Point Beach Nuclear Plant, Units 1 and 2
Dockets 50-266 and 50-301
License Nos. DPR-24 and DPR-27

Response to Request for Additional Information
Regarding the Point Beach Nuclear Plant License Renewal Application
(TAC Nos. MC2099 and MC2100)

RESPONSE TO REQUEST FOR ADDITIONAL INFORMATION REGARDING POINT BEACH NUCLEAR PLANT, UNITS 1 AND 2 LICENSE RENEWAL APPLICATION

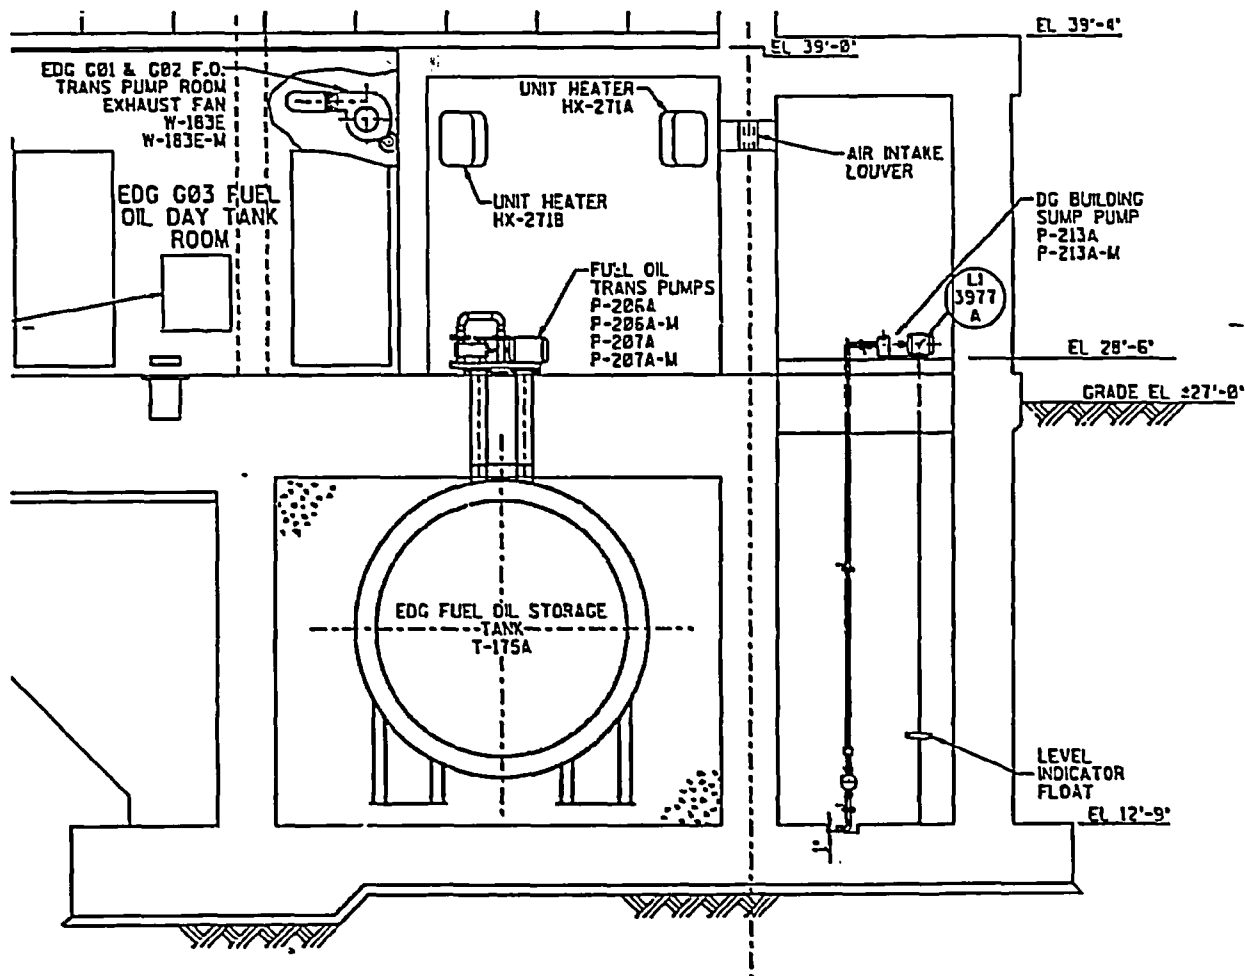
LRA Table 3.3.2-14 identifies the loss of material as an aging effect for carbon steel piping and fittings, and valve bodies in a raw water drainage environment. The applicant identifies the One-Time Inspection Program, LRA Section B2.1.13, to manage this aging effect. NUREG-1801, XI.M32 recommends one-time inspections as an appropriate aging management program where either an aging effect is not expected to occur but there is insufficient data to completely rule it out, or an aging effect is expected to progress very slowly. In cases where an aging effect is likely to occur, NUREG-1801 recommends periodic inspections. The staff does not consider a one-time inspection appropriate to manage the loss of material for carbon steel components in a raw water environment. The applicant is requested to justify use of a one-time inspection program to manage the loss of material for carbon steel components in a raw water environment.

The components in question are drainage and sump pump discharge piping and valves as shown on drawing LR-M-223, Sheet 3, location G-8. The internal environment is referred to as "Raw Water – Drainage," which typically consists of groundwater from the facade sumps. Groundwater at PBNP is a non-aggressive environment (see LRA Table 3.5.0-1, responses to items 12 and 13). As this is a non-aggressive environment, any aging effects would be expected to proceed very slowly. Plant operating experience over 34 years of operation has not identified leakage from these lines. Based on the non-aggressive environment and plant specific operating experience, the use of one-time inspections to manage this aging effect is considered acceptable. A one-time inspection will provide ample indication of the condition of these components prior to the period of extended operation. Note that the One-Time Inspection Program provides the option to change to periodic inspections or provide for repairs based on the results of the condition assessment after the one-time inspection.
